Findings of Fact | Site Plan Review

City of Portsmouth Planning Board

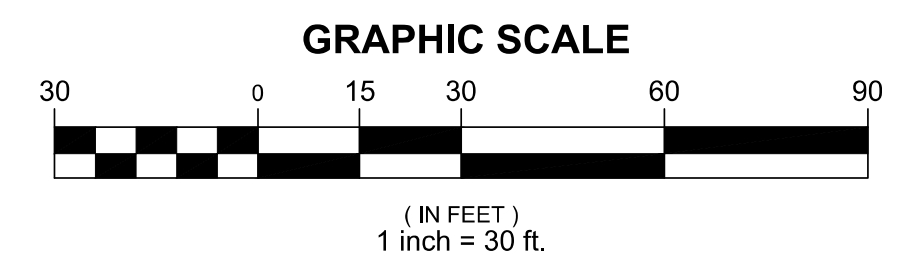
1	2025.01.16	REVISED PER TAC REVIEW COMMENTS	PJM	DJO			
REV.	DATE	DESCRIPTION	BY	CHK.			
DRAWING ISSUE STATUS							
ISSUED FOR PERMITTING							
		HALEY WARD					
WWW.HALEYWARD.COM		200 Griffin Rd., Unit 14 Portsmouth, New Hampshire 03801 603.430.9282					
PROJECT							
1151 SAGAMORE AVENUE CBC, LLC 1151 SAGAMORE AVE., PORTSMOUTH, NH							
TITLE							
PRE-DEVELOPMENT HYDROLOGY PLAN							
		DATE	2025.12.22	SCALE	1"=30'		
		DRAWN BY	BLO/PJM	DESIGNED BY	BLO/PJM	CHECKED BY	DJO
		PROJECT No.	5010314.002			REV.	
		DRAWING No.	C701			REV.	1

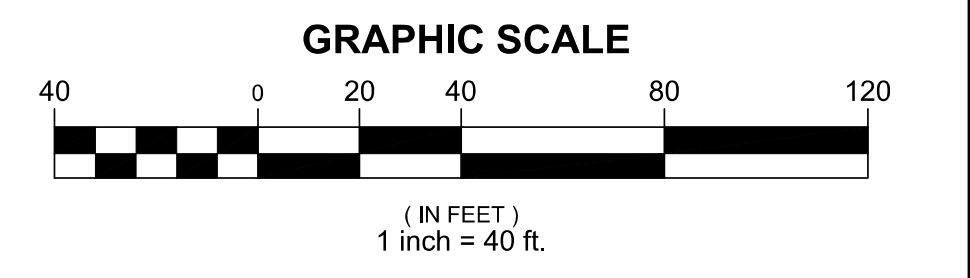
1	2025.01.16	REVISED PER TAC REVIEW COMMENTS	PJM	DJO
REV.	DATE	DESCRIPTION	BY	CHK.

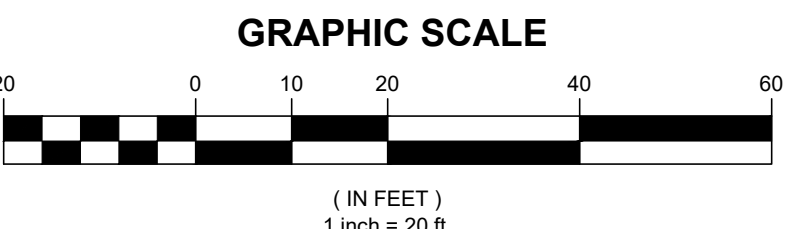
- CONDITIONS OF APPROVAL:**
- ALL CONDITIONS ON THIS PLAN SHALL REMAIN IN EFFECT IN PERPETUITY PURSUANT TO THE REQUIREMENTS OF THE SITE PLAN REVIEW REGULATIONS.
 - THIS SITE PLAN SHALL BE RECORDED IN THE ROCKINGHAM COUNTY REGISTRY OF DEEDS.
 - ALL IMPROVEMENTS SHOWN ON THIS SITE PLAN SHALL BE CONSTRUCTED AND MAINTAINED IN ACCORDANCE WITH THE PLAN BY THE PROPERTY OWNER AND ALL FUTURE PROPERTY OWNERS. NO CHANGES SHALL BE MADE TO THIS SITE PLAN WITHOUT THE EXPRESS APPROVAL OF THE PORTSMOUTH PLANNING DIRECTOR.

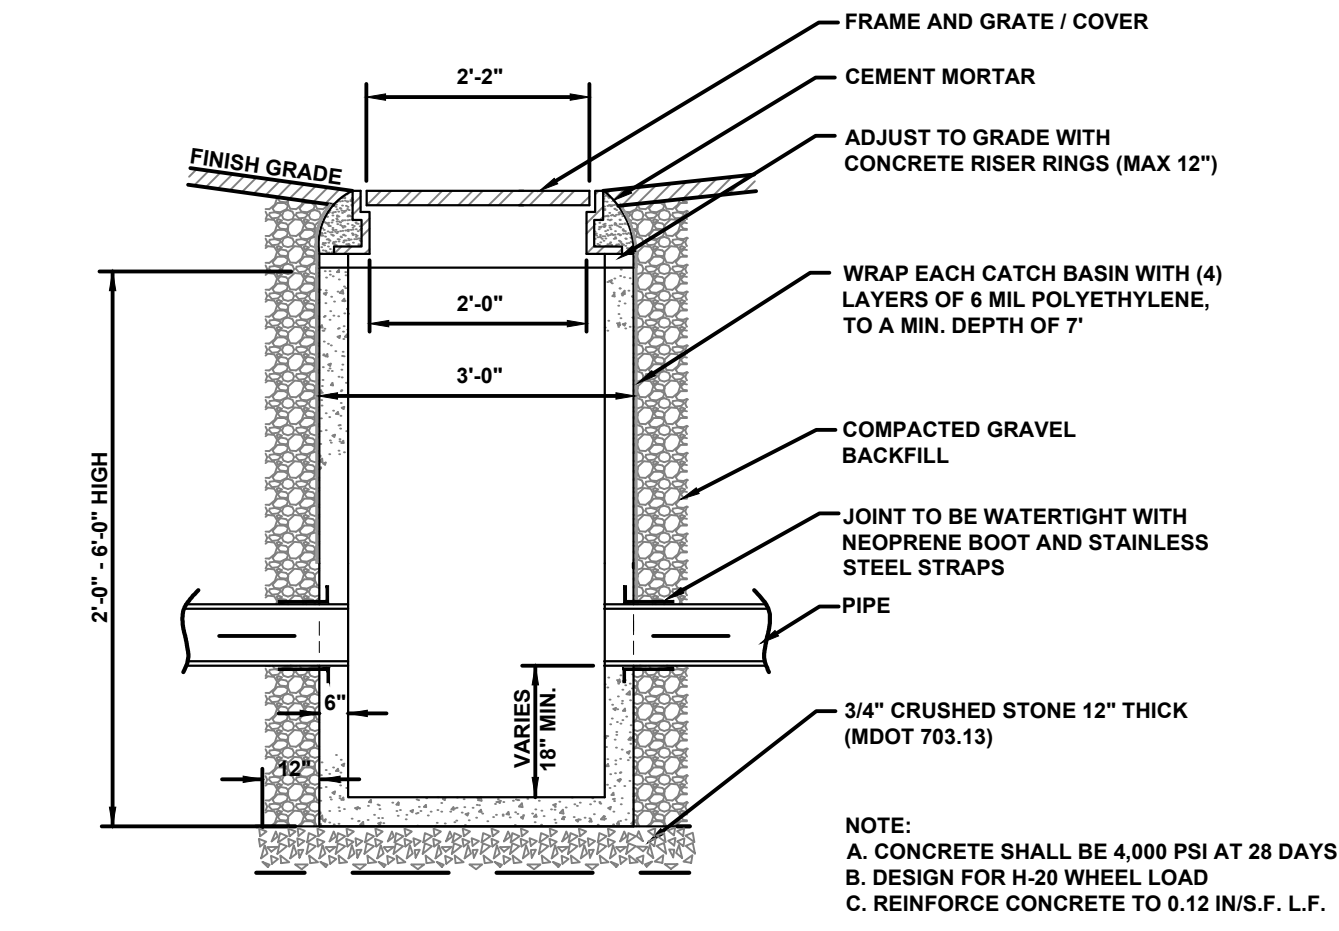
REV.	DATE	DESCRIPTION	BY	CHK.
3	2026-03-02	REVISED PER TAC REVIEW COMMENTS	PJM	DJO
2	2026-02-13	REVISED PER TAC REVIEW COMMENTS	PJM	DJO
1	2026-01-16	REVISED PER TAC REVIEW COMMENTS	PJM	DJO

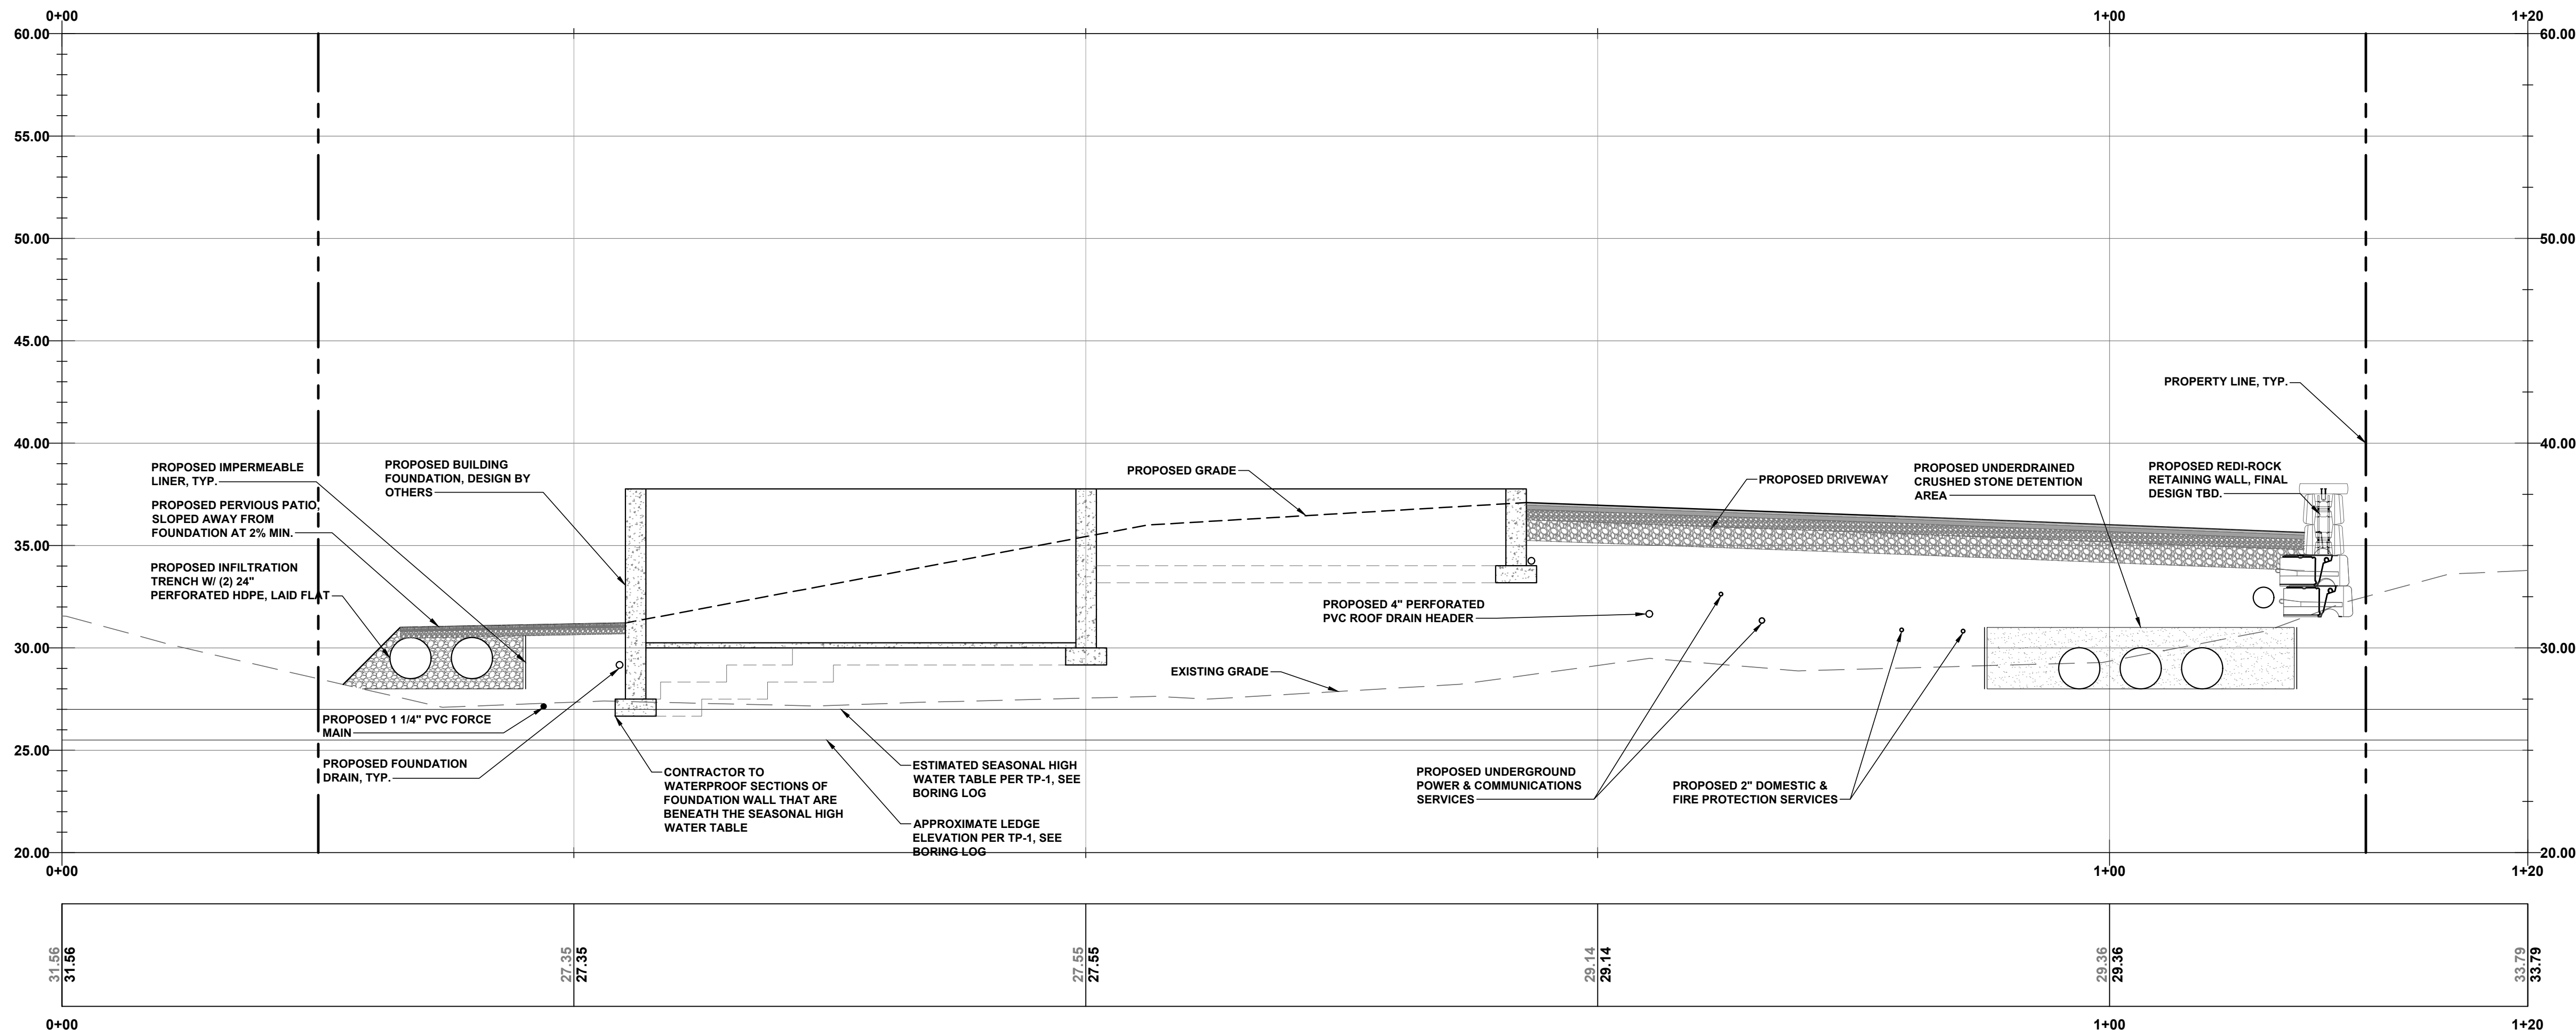
3	2026-03-02	REVISED PER TAC REVIEW COMMENTS	PJM	DJO
2	2026-02-13	REVISED PER TAC REVIEW COMMENTS	PJM	DJO
1	2026-01-16	REVISED PER TAC REVIEW COMMENTS	PJM	DJO
REV.	DATE	DESCRIPTION	BY	CHK.

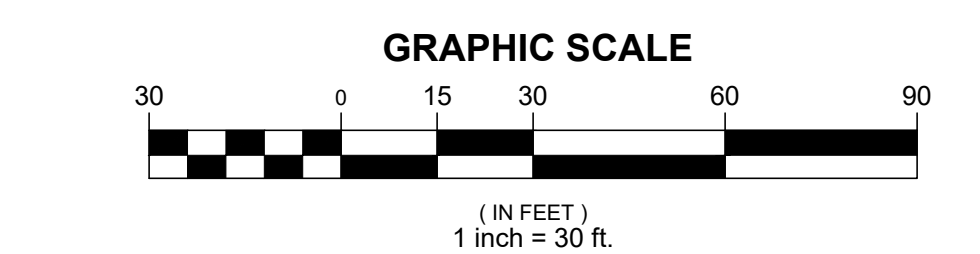
REV.	DATE	DESCRIPTION	BY	CHK.
3	2025.03.02	REVISED PER TAC REVIEW COMMENTS	PJM	DJO
2	2025.02.13	REVISED PER TAC REVIEW COMMENTS	PJM	DJO
1	2025.01.16	REVISED PER TAC REVIEW COMMENTS	PJM	DJO

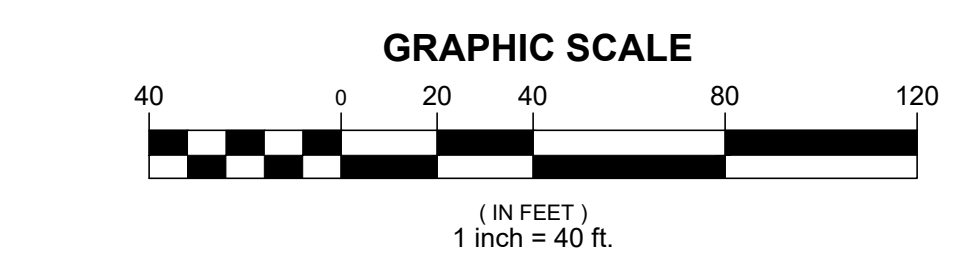
REV.	DATE	DESCRIPTION	BY	CHK.
3	2025.03.02	REVISED PER TAC REVIEW COMMENTS	PJM	DJO
2	2025.02.13	REVISED PER TAC REVIEW COMMENTS	PJM	DJO
1	2025.01.16	REVISED PER TAC REVIEW COMMENTS	PJM	DJO
